SIB 41 07 25

CRACKING SOUND FROM THE REAR WHEEL ARCH PANEL

2026-01-07

This Service Information Bulletin (Revision 1) replaces SI B41 07 25 **dated August 2025**

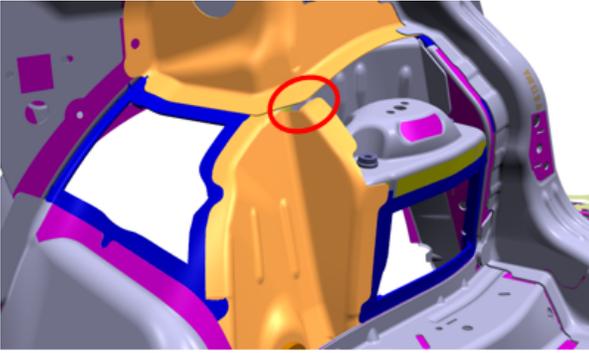
Red arrow is pointing to the area of where the sound is occurring (**with the wheel arch panel installed** (highlighted in orange; driver's side shown)).

Red circle indicates the area of where the sound is occurring (**without the wheel arch panel installed** (highlighted in orange)).

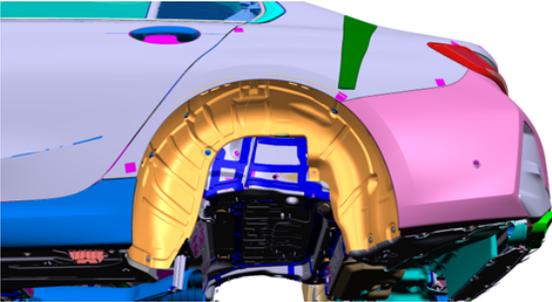
The wheel arch support panel may slightly overlap the side frame connection under certain circumstances. Tensile and compressive loads can cause movement between the panels resulting in a “cracking” sound.

Rework the rear upper section of the left and/or right-side wheel arch panel.

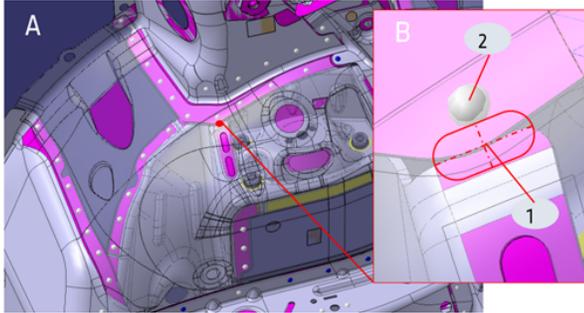
5. Drill an elongated hole (1) of approximately 15 mm in length into the left and/or right wheel arch panel (**transparent photo B for reference**).

Important note: Maintain a distance of 4 mm to the spot weld (2)!

Note: Wheel arch panel thickness is 1 mm.

6. Weld the elongated hole (1). The two panels underneath must be welded to the wheel arch panel.
